# Appendix F

Consolidated Response to Comments on:

***Definitions and Recommended Nutrient Reduction Efficiencies of Nutrient Application Management for Use in Phase 5.3.2 of the Chesapeake Bay Program Watershed Model (June 25, 2015)***

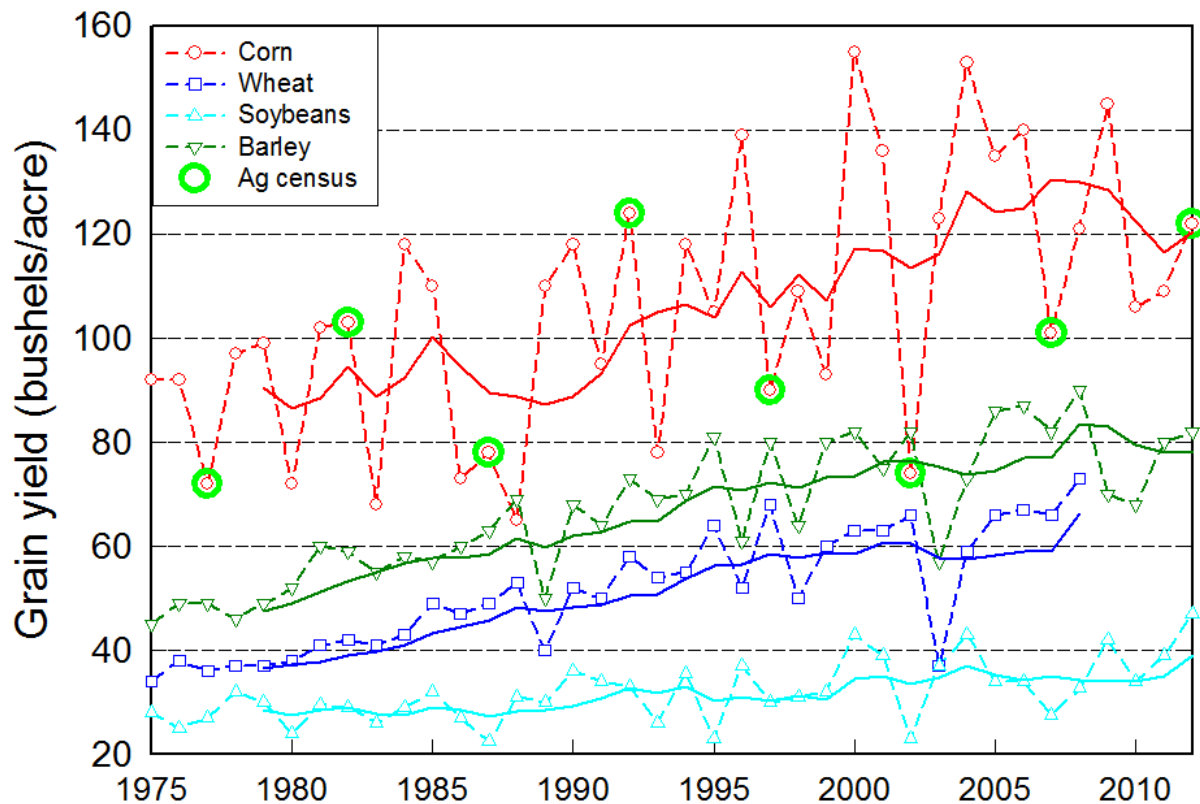
So, is this suggesting that the reason we haven't documented an actual decrease in N application historically is because yields have increased? If so, then as noted above, providing data to support this assertion is important. [CBF]

Hmm, results of CEAP data indicate an increase in fertilizer/manure application in recent years. The Panels' response to this observation is that yields have also increased...again, data to support this assumption should be provided. [CBF]

*Response: Yield data included in the model is based upon 5 year intervals of Ag Census interpolated for annual yield data in the CBWM. Specifically illustrated in Maryland as illustrated, Ag Census yield data was collected on disproportionately low yield years compared to average annual yields collected by the National Ag Statistics Service. The chart appended below shows a clear trend in corn yields increasing through time and point data from Ag Census occurring at noticeably low levels, presumably due to weather. This skewing of the data incorporated into the Phase 5.3.2 CBWM results in low estimations of N and P application rates by the Phase 5.3.2 CBWM and obfuscates the improvements in expected yield of roughly 30% during the simulation period. Also included in the analysis, performed by a panel member, are the major row crops, wheat, soybeans and barley which make up the vast majority of high till with manure acres simulated in the CBWM.*

*Response: Yield data has been provided above to support the report's claim of yield increases driving the more modest increases in N and P application rates Bay-wide.*
